## MILPITAS PLANNING COMMISSION AGENDA REPORT

**TITLE: "S" ZONE-APPROVAL AMENDMENT**

Proposal: Request to replace seven existing cabinet logo signs with (2) new internally illuminated individual channel letter wall signs.

Location: 755 Yosemite Drive

BUDWEISER SELF CONTAINED CHANNEL LETTERS

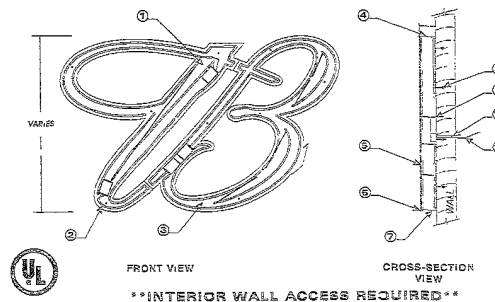
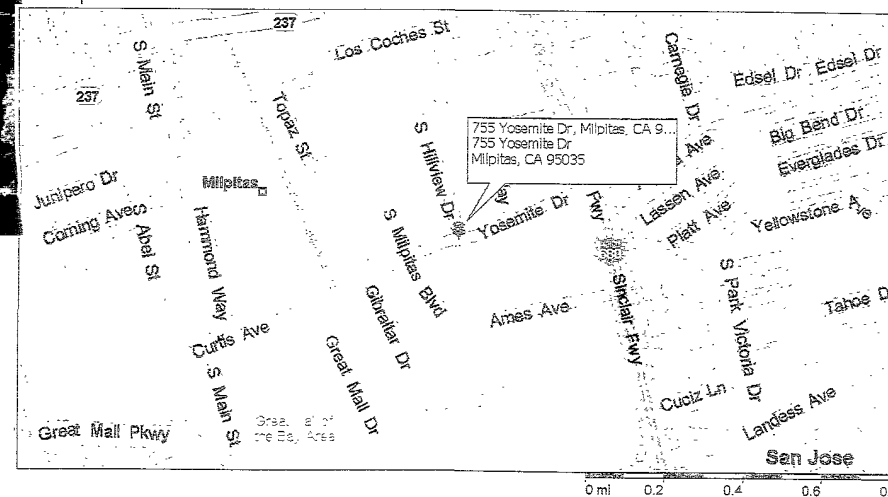
As shown in the above photo, the Bottomley sign consists of wall mounted, non-illuminated individual letters painted to match and complement the existing building. The proposed signage on the south elevation will be individual letters 4' in height and internally illuminated. Individual letters will be painted red with a gold trim. The interior of the letters will be painted

white for enhanced illumination. The proposed signage would be incompatible with the existing Bottomley Distributing sign. The sign type and height of proposed sign are different and proportionately larger than the existing Bottomley sign.

**CORONA SELF-CONTAINED CHANNEL LETTERS**

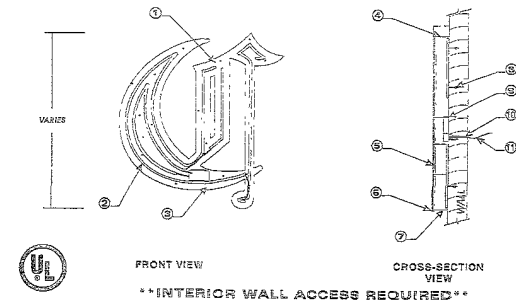
The applicants are also proposing to replace an existing logo channel sign with another 4' internally illuminated channel sign on the east side of the building that fronts Hillview Drive. The individual letters will be painted blue with blue trim. The interior of the letters will also be painted white for enhanced illumination. The proposed sign design would be inconsistent with the signage on south elevation. "Corona" would be the only sign that would appear on the building façade.

The proposed signs would detract from the existing signage on the building and from the adjacent properties because of its scale and mass on the east elevation. Signage for R&D buildings located east of Bottomley building consists of freestanding monument signs and no wall signs. Signage located south of the subject site consists of individual channel letters, however the lettering height is slightly smaller.
